WSN9- Replacing Plastic Slide On Three-Point Front Seat Belt (Workshop Campaign)

Model Year: **As of 2024 up to 2026**

Model Line: **Macan (XAB)**

Concerns: **Three-point front seat belt on passenger side**

*Plastic slide without belt loop**Plastic slide with belt loop*

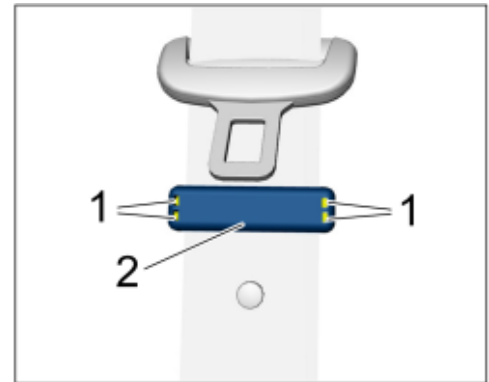
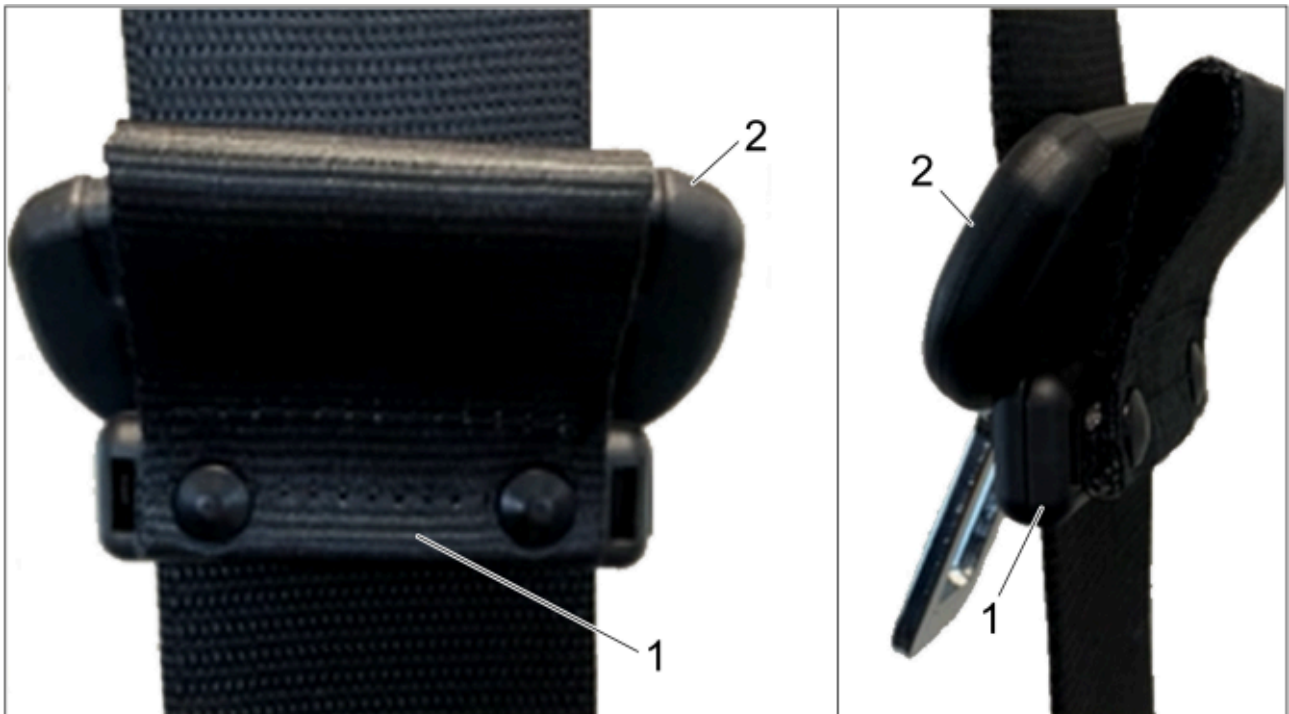
Cause: **On the affected vehicles, there is a possibility that on the passenger side rattling noises could occur on the B-pillar due to the free-swinging belt tongue of the three-point seat belt.**

Action: Replace plastic slide on the three-point seat belt on the passenger side with a plastic slide with belt loop.

- Work Procedure:
- 1 Loosen retaining lugs \Rightarrow *Plastic slide without belt loop -1-* on the plastic slide \Rightarrow *Plastic slide without belt loop -2-* using a suitable tool, \Rightarrow *Plastic slide without belt loop -2-* open plastic slide and remove.
 - 2 Fasten **new** plastic slide with belt loop \Rightarrow *Plastic slide with belt loop -1-* to belt strap. Make sure that the belt loop under the belt tongue is pointing \Rightarrow *Plastic slide with belt loop -2-* upwards.

- 3 Fasten the removed plastic slide **without** belt loop to the three-point seat belt on **the driver's side**.
- 4 Enter the campaign in the Warranty and Maintenance logbook.
